SUMMARY
1234 Main St. Wellington 6022
Buyer Name
10/27/2018 9:00AM

Adam Collins
LBP; NZQA in Carpentry
(advanced), Roofing level 4, Asbestos
Identification
inquest.co.nz
+64 210372132
inquest.kiwi@gmail.com

10.1.1 Weatherboard - Timber

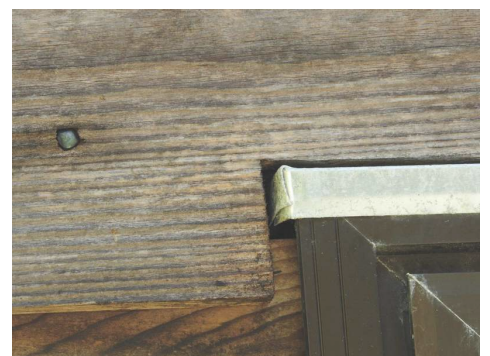
FLASHING

Some of the cutouts around the window head flashings have not been done properly and may be leaking during times of stormy weather.

The raking windows should have kick out flashings, this in a modern building requirement because these have been known to leak.

Contact a qualified carpenter.

10.1.2 Weatherboard - Timber

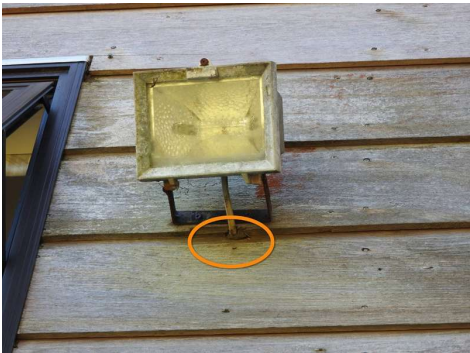
WALL PENETRATIONS

Some attention required around the pipe penetrations.

The electrical meter box should have a head flashing and side scribes

The windows on the back wall (master bedroom an ensuite) have no scribe plugs, this is poor workmanship and may be leaking during times of stormy weather

The floodlight by the kitchen has an exposed cable that is a high risk of rainwater ingress. these should be monitored.

Contact a qualified handyman.

14.2.1 Back porch

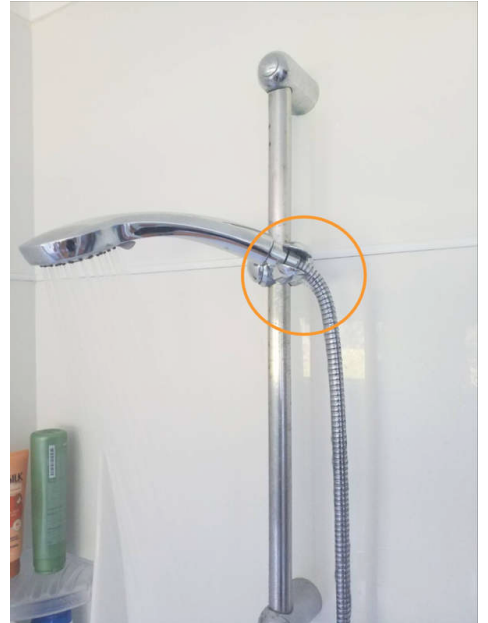
THRESHOLD - TO PERMANENT PATH

Water may splash onto absorbent cladding or track inside.

NZS 3604, gives a minimum threshold height of 150 mm at an opening onto a permanent path.

Contact a qualified concrete contractor.
